**DECLARATION FOR THE EXPLANATION
OF SIGNIFICANT DIFFERENCES
SAVAGE MUNICIPAL WATER SUPPLY WELL SUPERFUND SITE
December 19, 1996**

Savage Municipal Water Supply Well Superfund Site
OK Tool Source Area, Operable Unit 1
Milford, New Hampshire

EXPLANATION OF SIGNIFICANT DIFFERENCES SAVAGE MUNICIPAL WATER SUPPLY WELL SUPERFUND SITE

Figure 1: October 1996

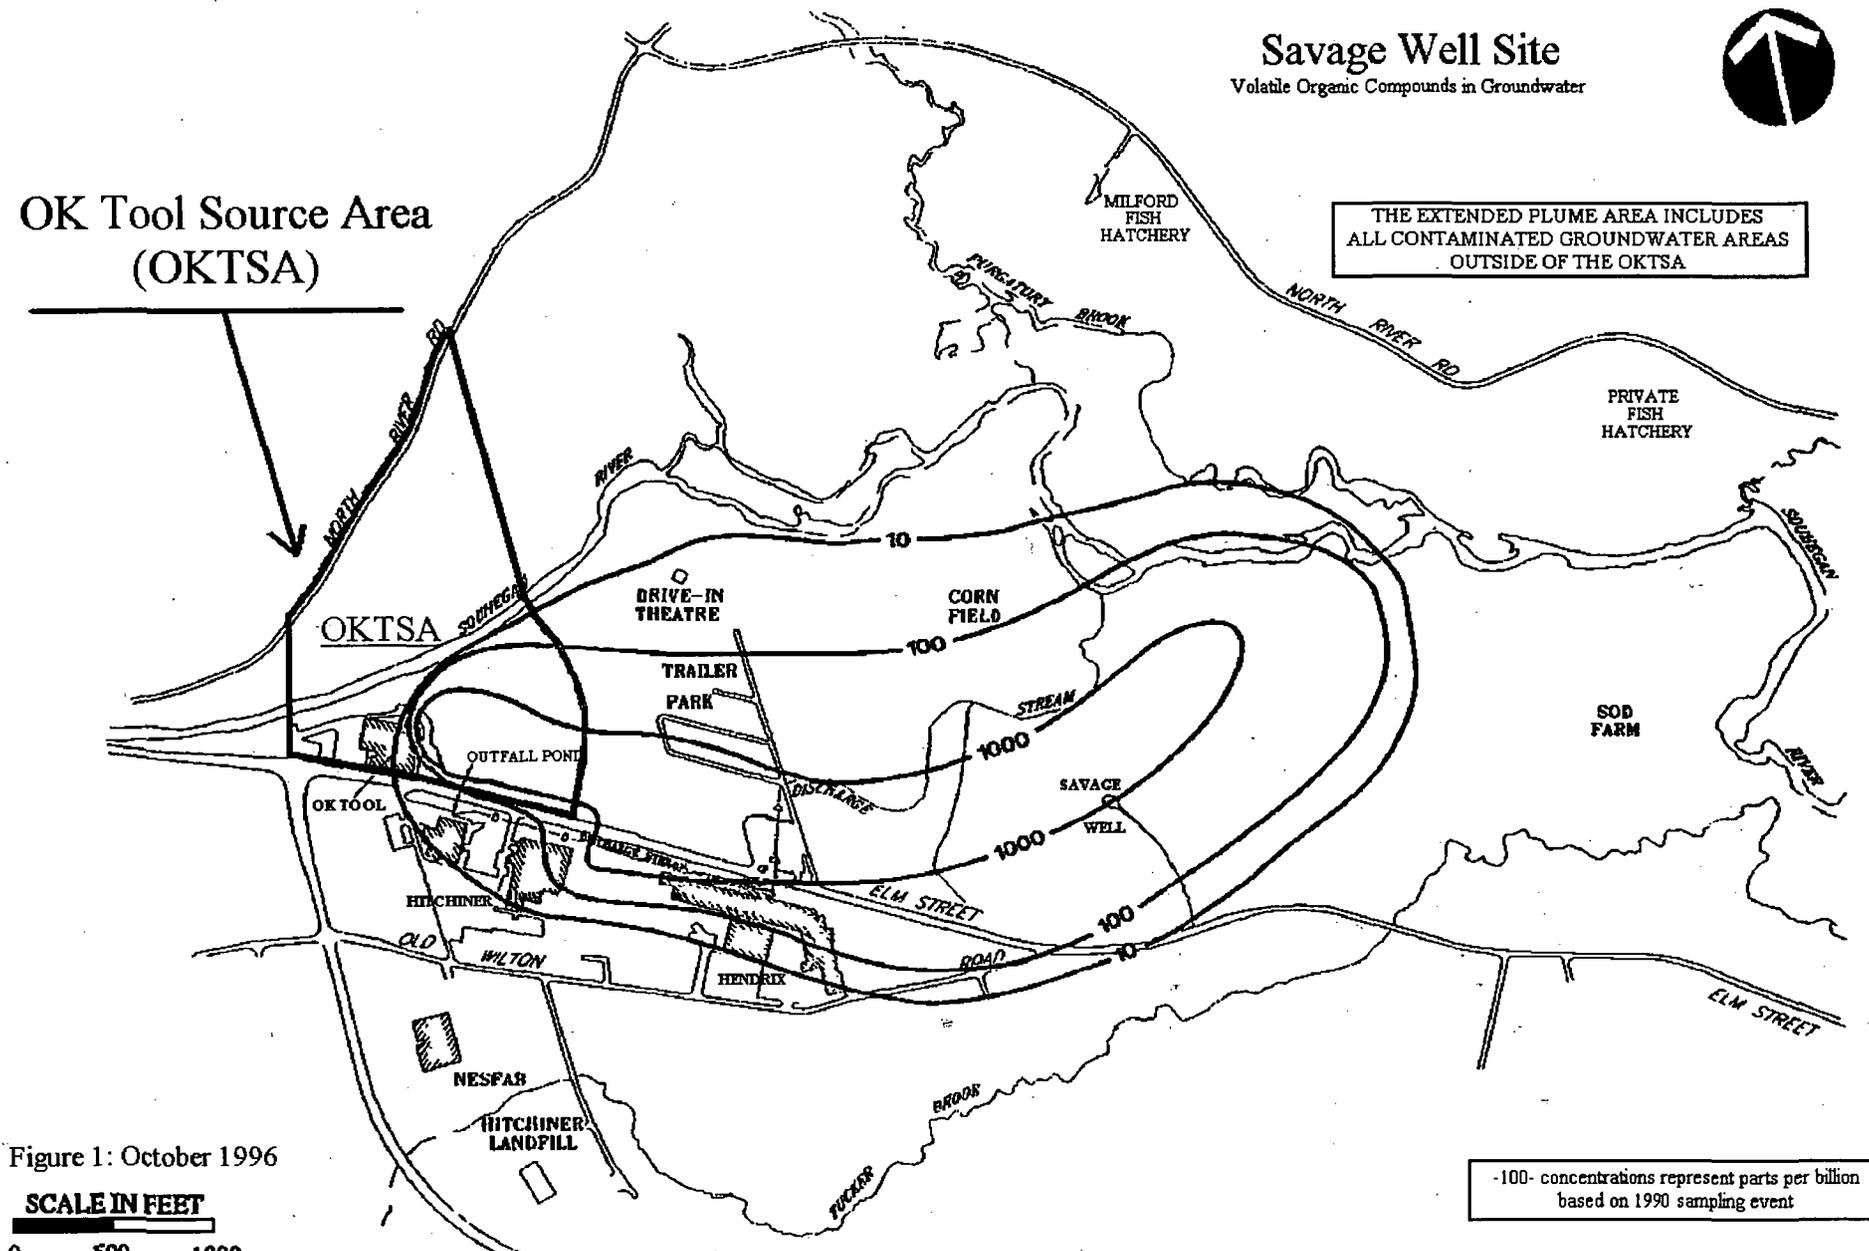
Company). The terms of the Consent Decree did not change the original goal of restoring the aquifer to drinking water quality. The agreed upon division of work is shown on the attached map (See Figure 1) which delineates the OK Tool Source Area (OKTSA) and the Extended Plume. The remedial work in the OKTSA is being funded by the federal and state governments in accordance with the Hazardous Waste Superfund Program. The remedial work in the Extended Plume is being funded by the Performing Parties. The Consent Decree and the attached Statement of Work (SOW) created a mixed work site where long-term successful remediation in the Extended Plume Area is dependent upon successful remediation efforts in the OKTSA. The SOW allows the Performing Parties to stop remediation efforts after 30 years if contamination from the OKTSA is the reason that the Performing Parties are unable to attain the ROD cleanup goals.

Figure 2

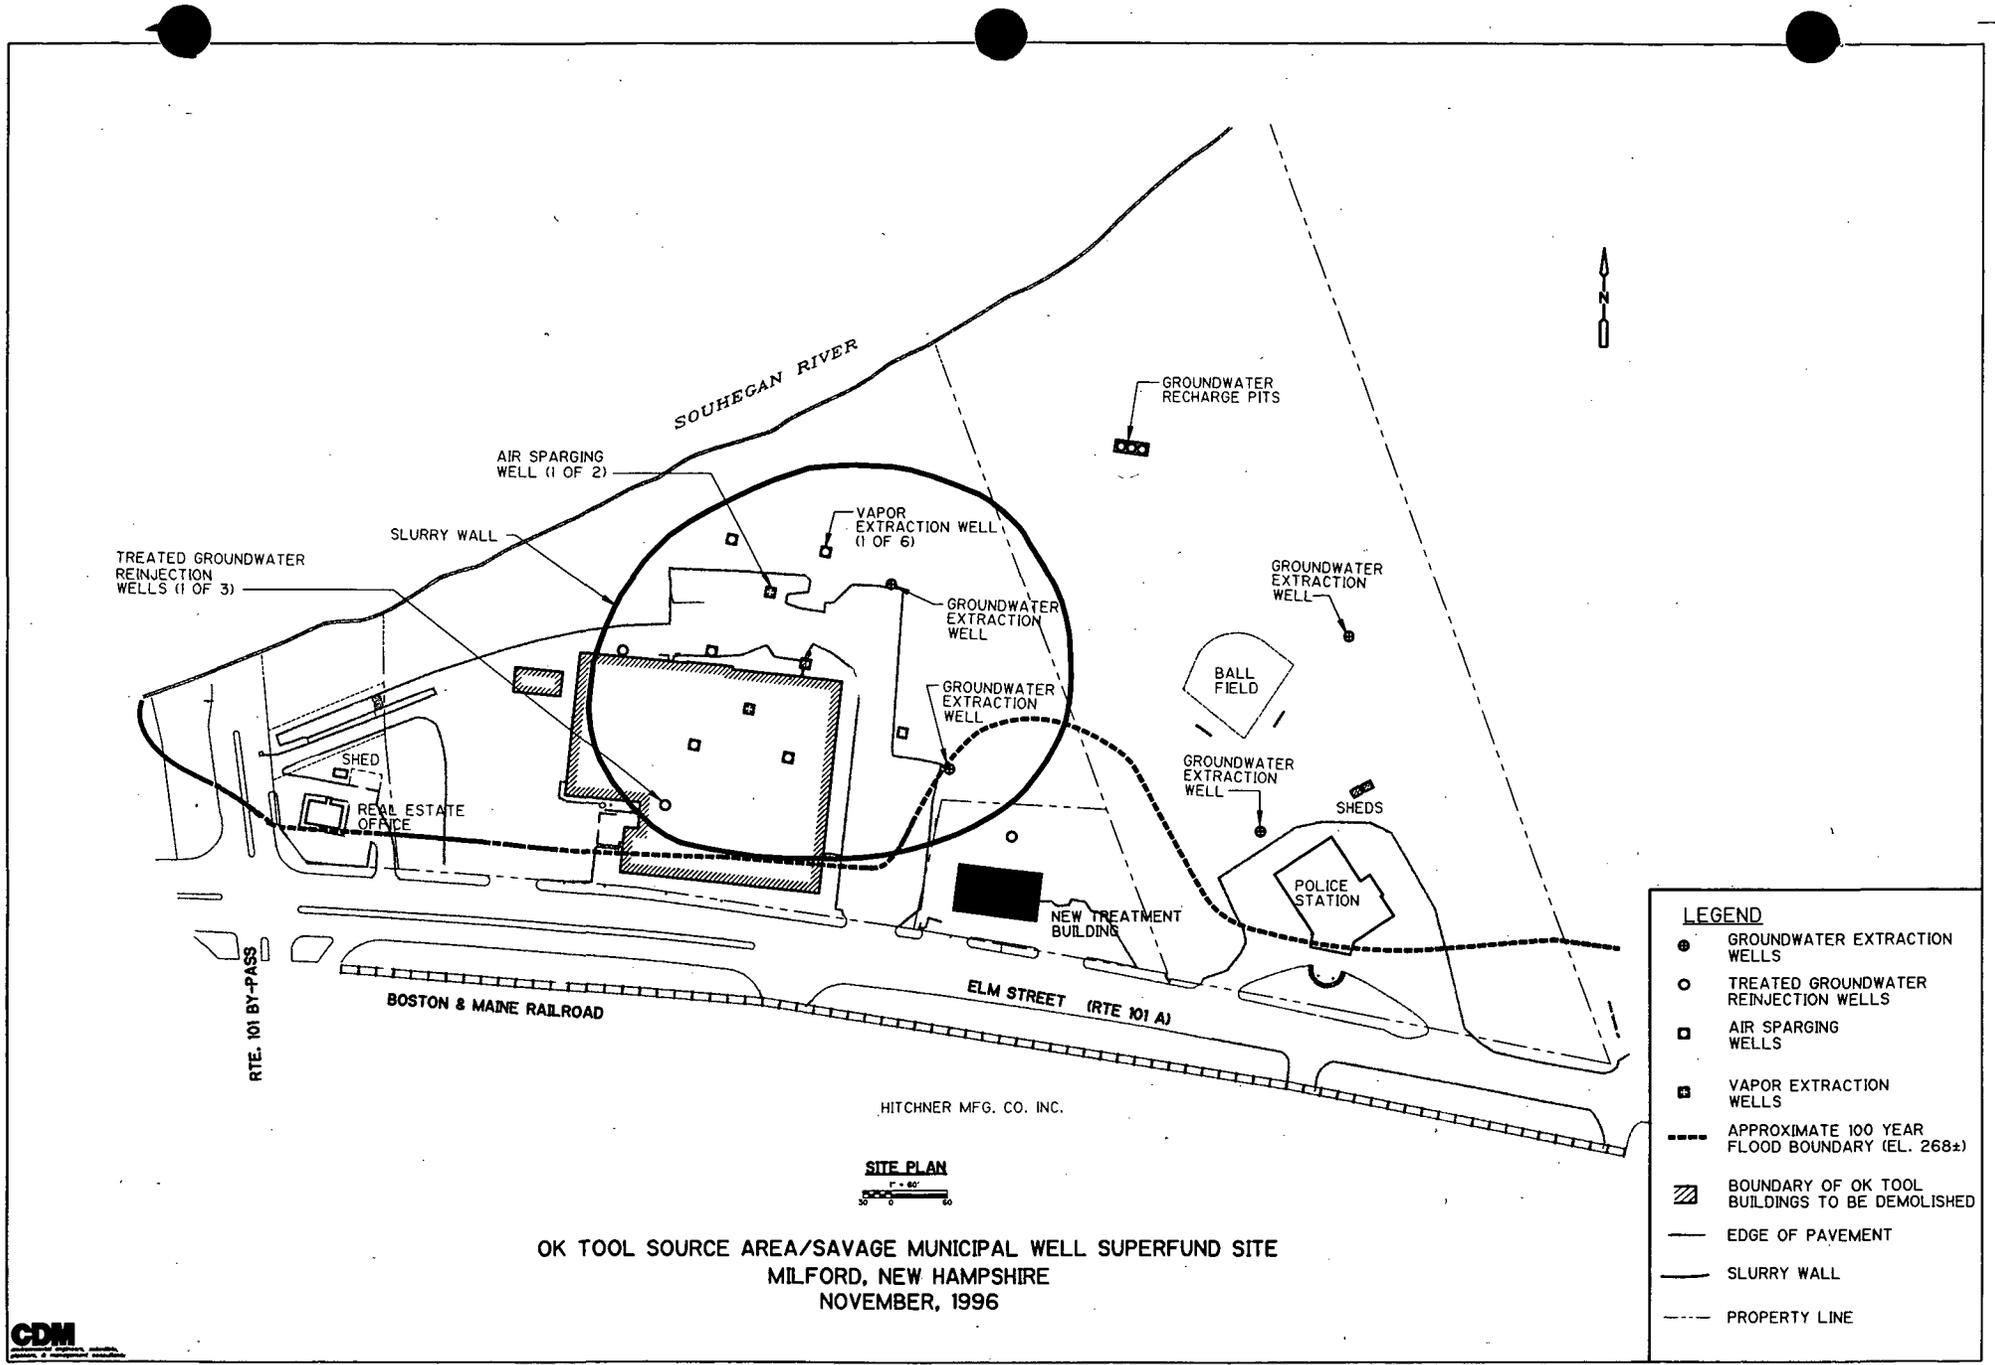
The remedy continues to use the pumping of groundwater where appropriate. Groundwater will be removed at the rate of 20 gpm from the lower depths of the area within the slurry wall using two extraction wells. There will also be two extraction wells

located outside the slurry wall to capture dissolved contamination that is between the slurry wall and the boundary of the OKTSA. The wells outside the wall will pump at a removal rate of 50 gpm. The contaminated groundwater from all four wells will be treated using air stripping and the resulting contaminated air will be treated using activated carbon. The clean air will be discharged to the atmosphere. See Figure 2 for a plan of the components described for the remedy in the OKTSA.
